Re: Bogan Brothers Painting
3435 Vassar Dr., NE
Traffic Circulation Layout
Engineer's/Architect's Stamp **6-6-16** (G16-D150)

Based upon the information provided in your submittal received 6-21-16, the above referenced plan cannot be approved for Building Permit until the following comments are addressed:

TCL

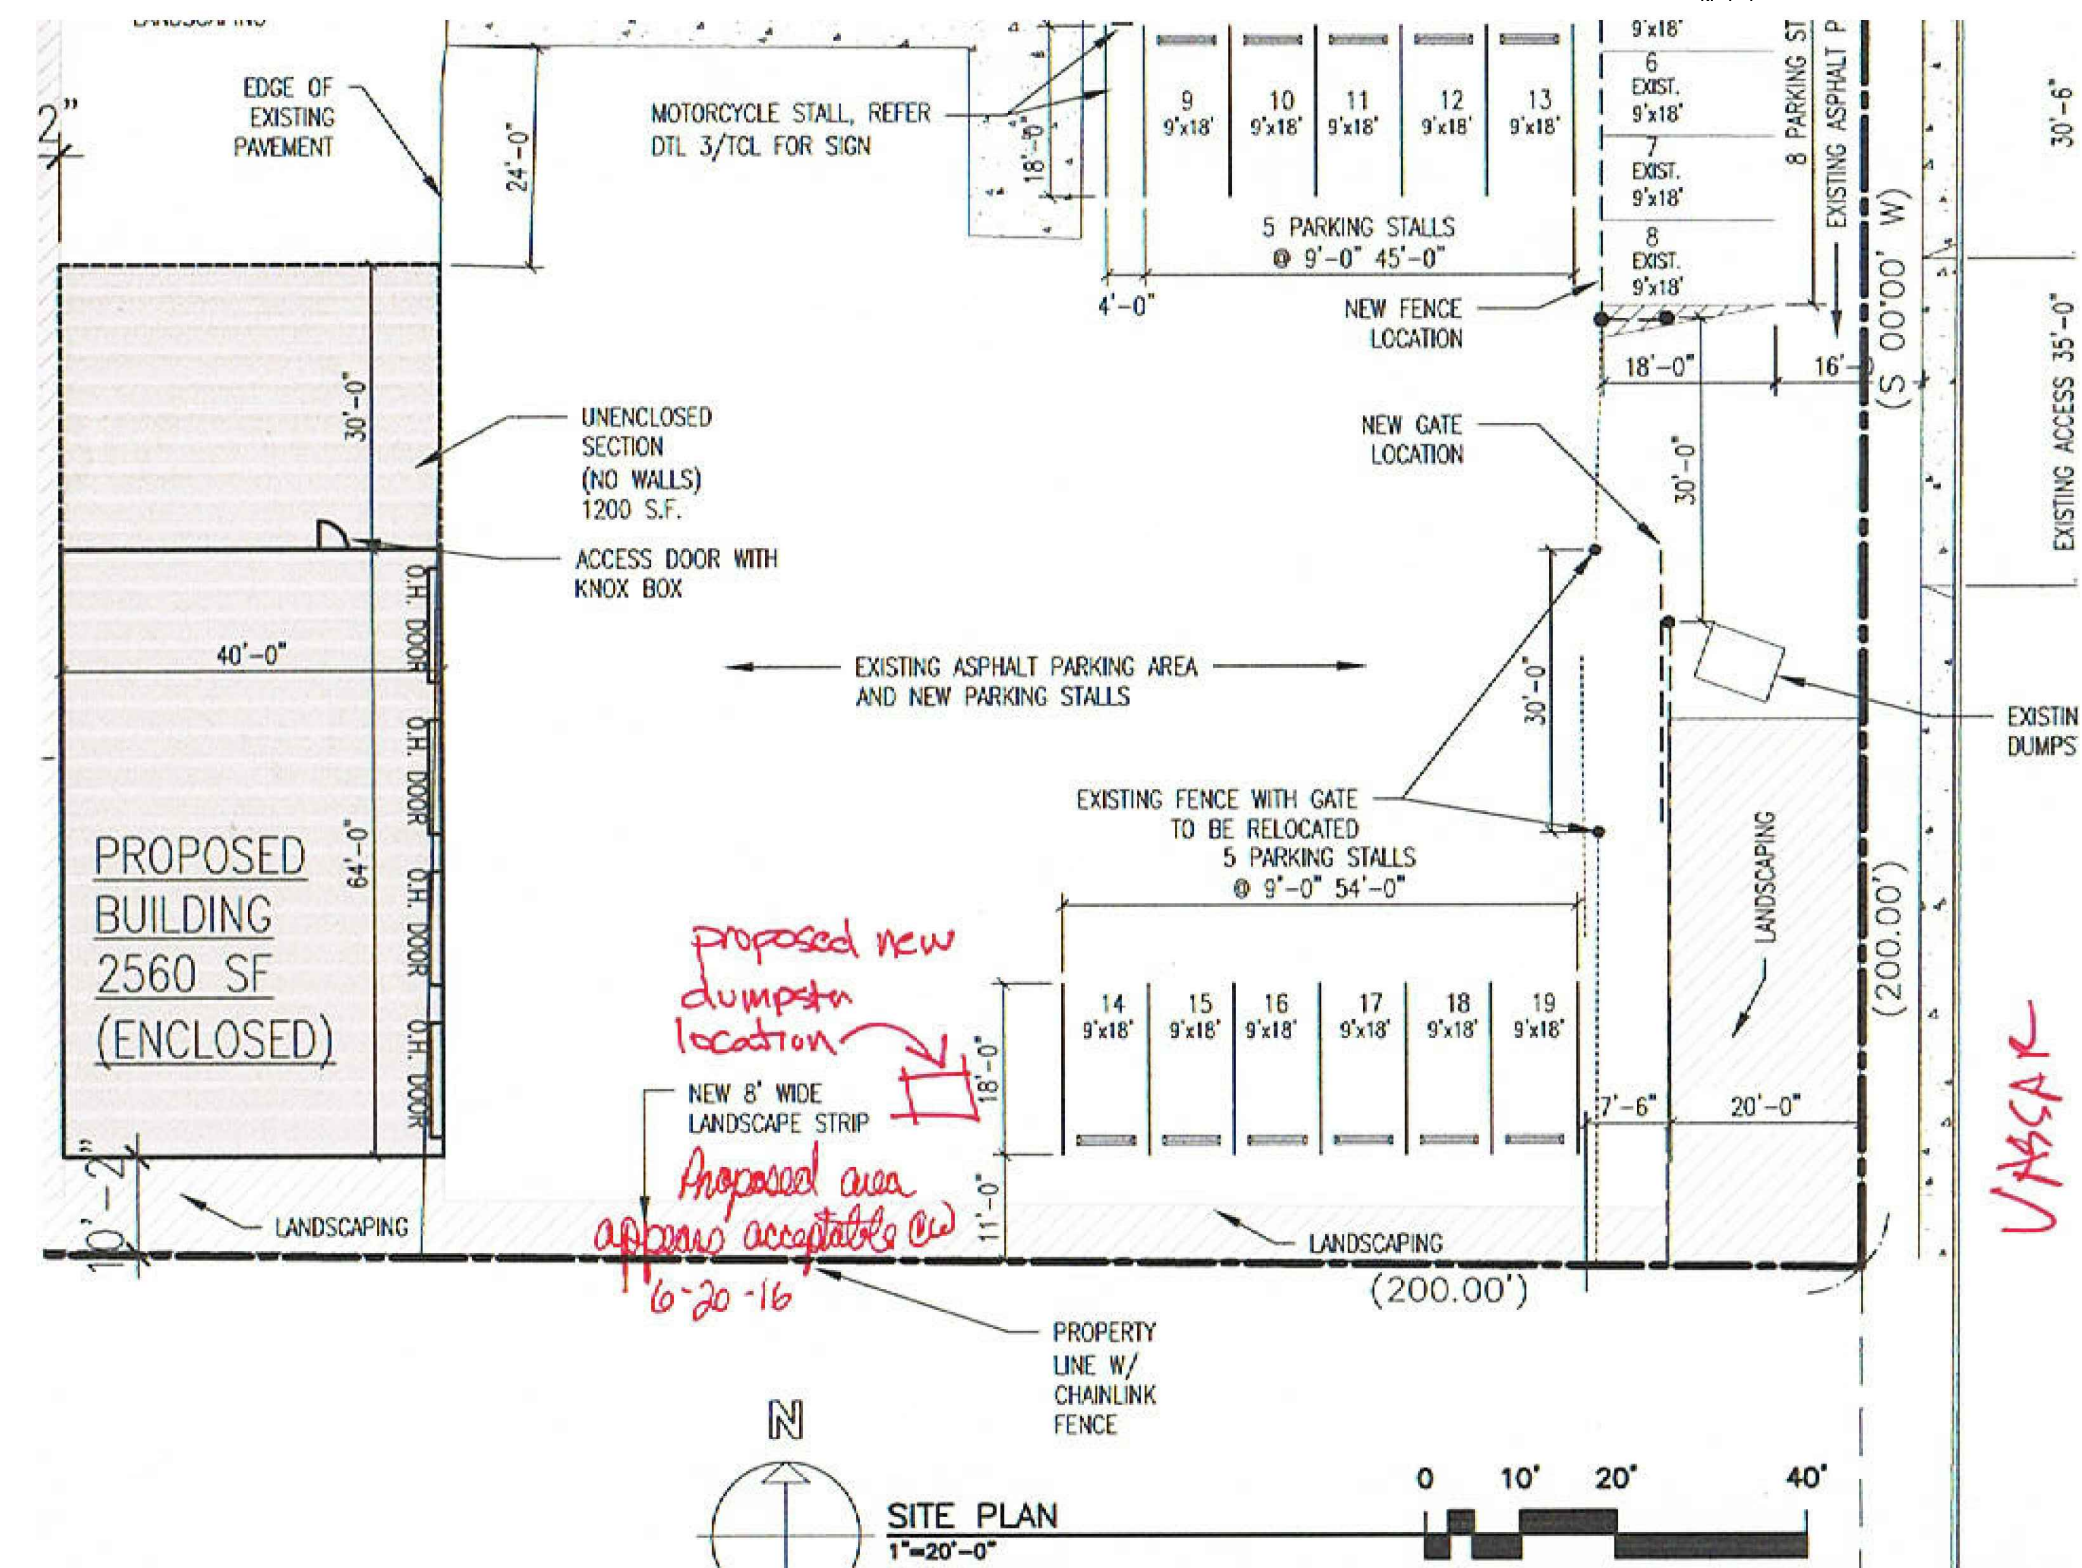
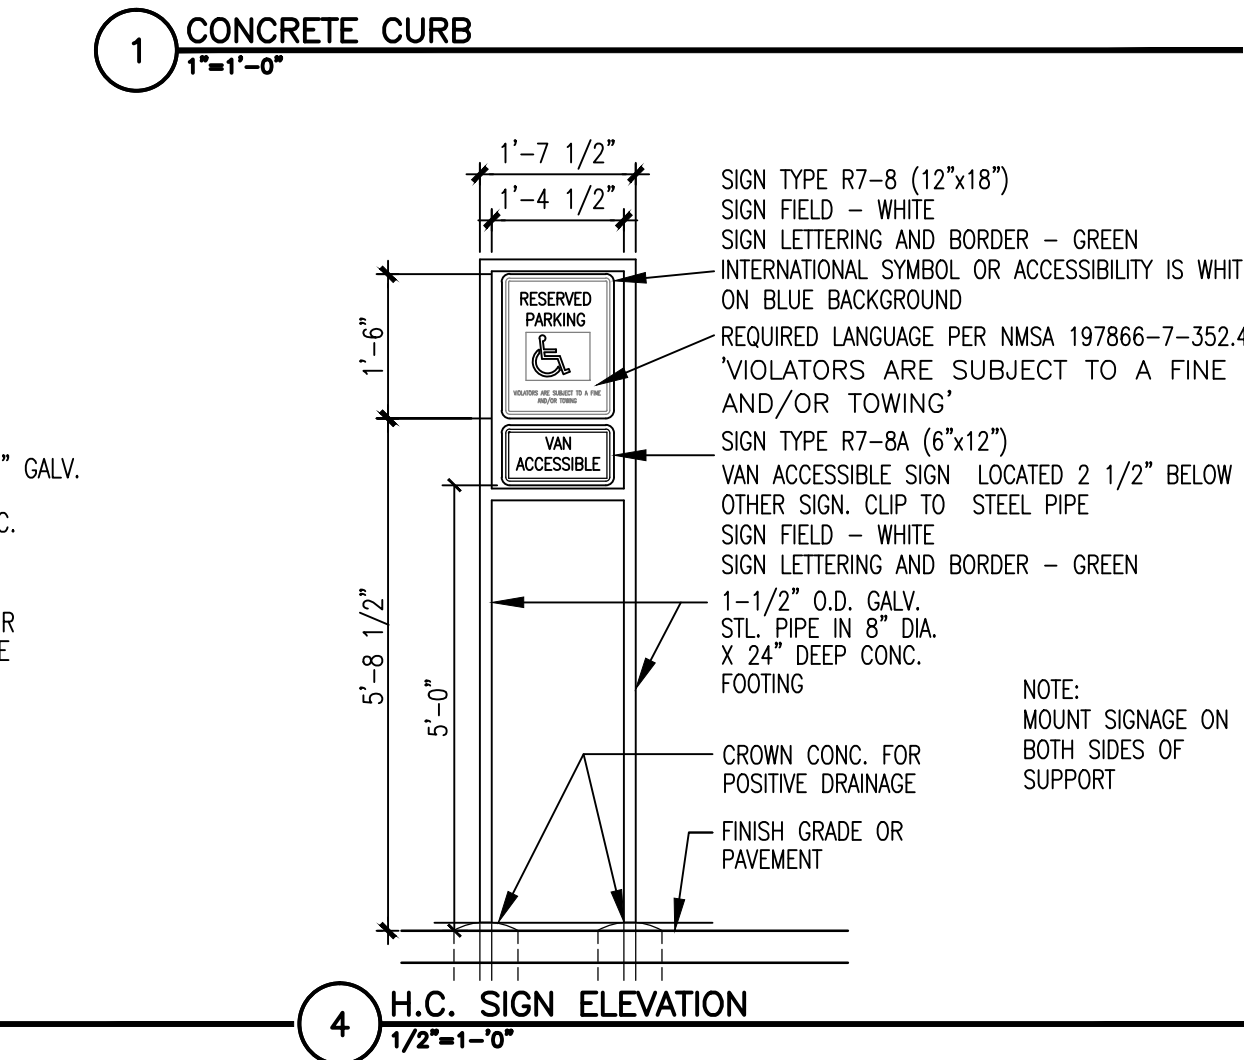
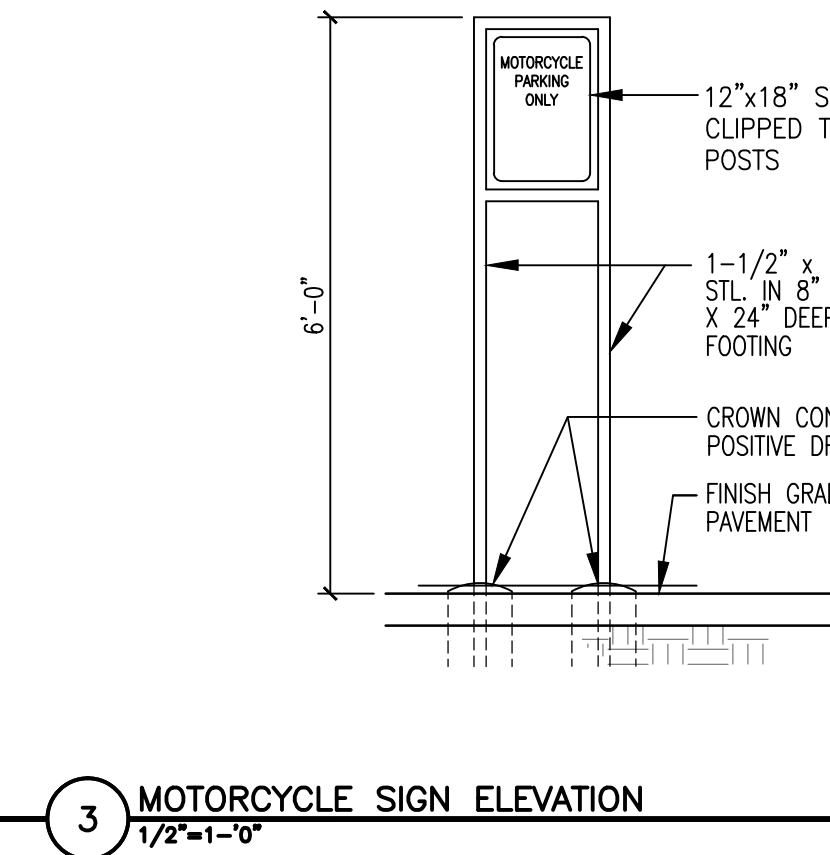
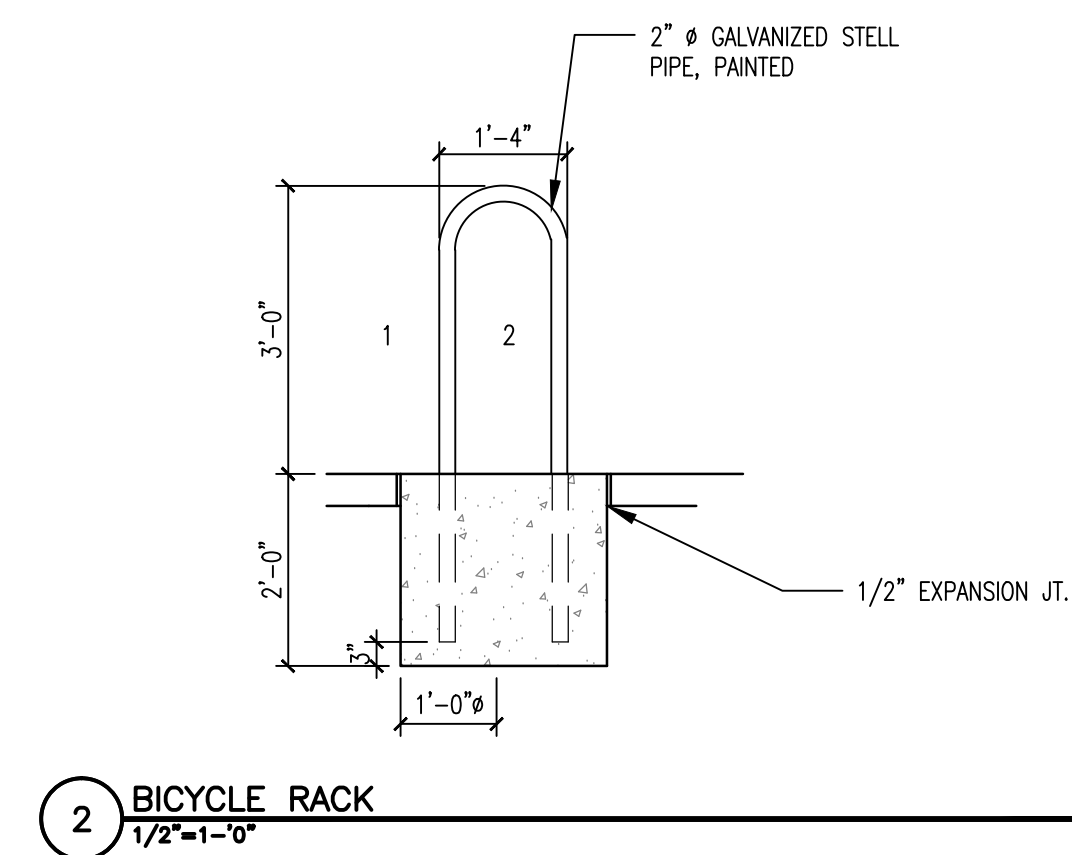
1. Please detail and dimension all buildings, parking spaces and ADA ramps and anything that influences the parking and circulation on the site. Previous digital maps show parking spaces on the north east corner of the parcel. Please detail the existing ADA ramps on the existing curb cuts.

2. Parking spaces are required to be a minimum of 8.5 ft. by 20 ft. In review of the submitted plans, the parking spaces on the east side of the existing building are not adequate in length and do not provide a minimum of 24 ft. drive pad between the parking spaces and the ROW for adequate backing up of vehicles. It is preferable that vehicles do not back up onto streets when exiting.

3. Per DPM, a 6 ft. wide ADA accessible pedestrian pathway is required from the HC parking stall access aisles to the building entrances. Please clearly show this pathway and provide details. Please dimension the access isle.

4. ADA parking spaces require a minimum of 8.5 ft. X 20 ft. per parking space. Please revise site plan to accommodate adequate ADA parking spaces and access isle. In review of the submitted site plan, the parking spaces are 16 ft. in length. Evaluate moving HC spaces to south east corner of the existing building and providing a 6 ft. pedestrian access to the building entrance. The parking spaces may also be angled, if appropriate for the design.

5. Service vehicle and/or refuse vehicle maneuvering must be contained on-site; provide a copy of refuse approval.
6. All broken or cracked sidewalk and ADA ramps must be replaced with sidewalk and curb & gutter. A build note must be provided referring to the appropriate City Standard drawing.
